Access Compliance Report

Public Rights-of-Way

(Curb Ramps)

Intersection ID: 24849	Main Street: KING_EIDER_DR	Cross Street: WIDGEON_CT	Location: SE
ADA ID: AC0F37CDFBCD	Ramp Type: Directional1	Initial Pass/Fail: Fail	Overall Compliance: No
Severity Score: 37.5			
Codes/Mitigation Info/Possible Solution		Field Measurements/Component Compliance

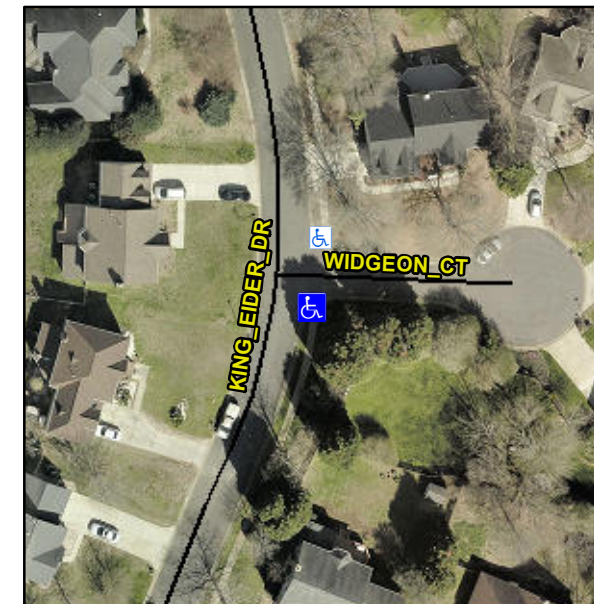
R304.2.2, R304.5.3

Compliance	Description	Data	Compliance	Description	Data
N/A	Ramp Length (in)	25.0	N/A	Grade Break?	N/A
Yes	Ramp Width (in)	48.0	N/A	Grade Break Slope (%)	0.0
No	Ramp Slope (%)	10.9	N/A	Grade Break XSlope (%)	0.0
No	Ramp XSlope (%)	7.2			
N/A	Flare Type LT	N/A	N/A	Flare Type RT	N/A
N/A	Flare Slope LT (%)	N/A	N/A	Flare Slope RT (%)	0.0
N/A	Flare Traversable LT?	N/A	N/A	Flare Traversable RT?	N/A
N/A	Landing Length (in)	0.0	N/A	DWS Provided?	N/A
N/A	Landing Width (in)	0.0	N/A	DWS Contrast?	N/A
N/A	Landing Slope (%)	0.0	N/A	DWS Length (in)	N/A
N/A	Landing X Slope (%)	0.0	N/A	DWS Full Width?	N/A
N/A	Landing Curb? (Y/N)	N/A	N/A	DWS Offset LT (in)	N/A
N/A	Shared Landing?	N/A	N/A	DWS Offset RT (in)	N/A
N/A	Gutter Ponding?	0.0	N/A	Gutter Slope (%)	N/A
N/A	Gutter Lip Ht (in)	0.0	N/A	Gutter X Slope (%)	N/A
N/A	Painted X Walk1?	No		Road Slope (%)	3.3
	X Walk 1 Direction	To N		Road X Slope (%)	3.7
	X Walk 1 Width (in)	N/A		Clear Space?	N/A

Remove & Replace Entire Ramp.
